# Work Order ID 73643

Item Name: Crosstube Turning Detail

<b>DART AEROSPACE LTD</b>	<b>Work Order:</b> 73643
<b>Description:</b> Crosstube Assembly (205/212 High Aft)	<b>Part Number:</b> D212-664-241
<b>Inspection Dwg:</b> D212-664-241 Rev: D	<b>Page 1 of 1</b>

DRAWING NO. D212-664-241	TITLE CROSSTUBE ASSY (205/212 HI AFT)	REV. D	DART AEROSPACE LTD. ENGINEERING ORDER		D.E.O. NO. D212-664-241-D-1	SHEET NO. SHEET 1 OF 2	SCALE NTS
DRAWN	CHECKED	MFG. APPR.	APPROVED	DE APPR.			
DATE 11.04.07	DATE 11.04.11	DATE 11.04.12	DATE 11/04/12	DATE 11.04.12

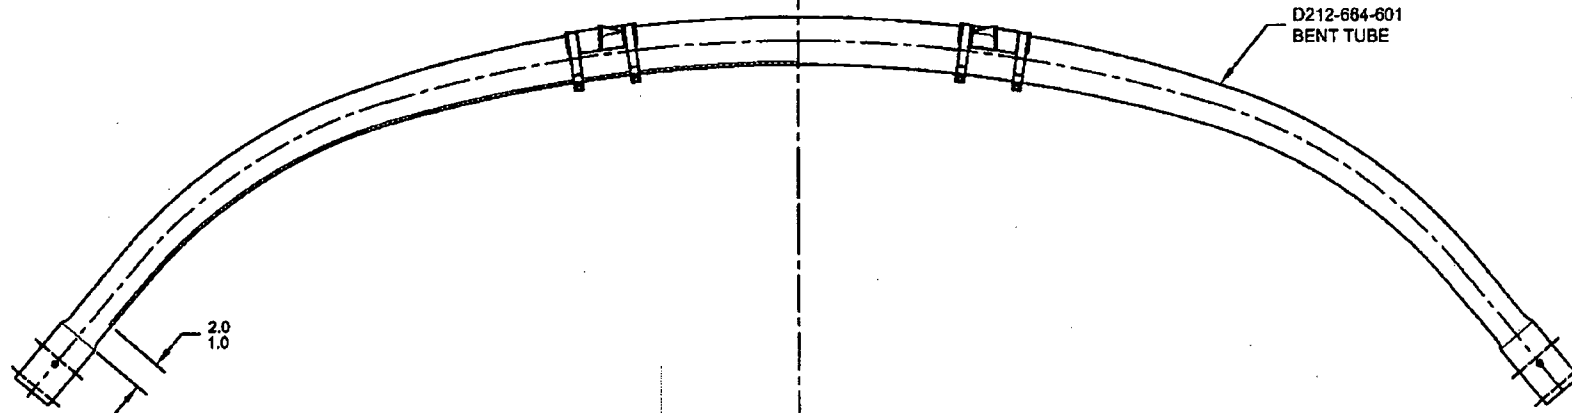
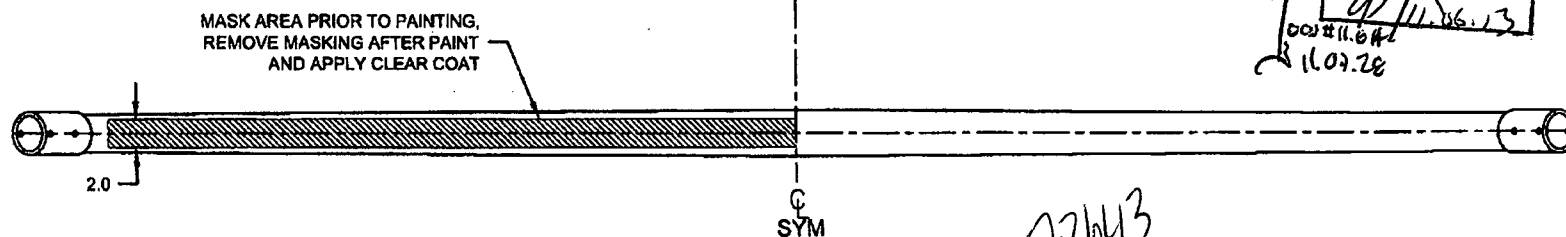
**PURPOSE:**

ADD AN INSPECTION WINDOW TO UNDERSIDE OF CROSSTUBE.

**CHANGE:**

NOTES 2 OF SHEET 1 IS AMENDED AS FOLLOWS:

**IS:**

- 2) FINISH: CHEMICAL CONVERSION COAT PER DART QSI 005 4.1  
PRIME INSIDE AND OUTSIDE PER DART QSI 005 4.2  
MASK UNDERSIDE OF CROSSTUBE AS SHOWN (HATCHED AREA) AND  
PAINT OUTSIDE PER DART QSI 005 4.2  
REMOVE MASKING AND APPLY CLEAR COAT

**WAS:**

- 2) FINISH: CHEMICAL CONVERSION COAT PER DART QSI 005 4.1  
PRIME INSIDE AND OUTSIDE PER DART QSI 005 4.2  
PAINT OUTSIDE PER DART QSI 005 4.2
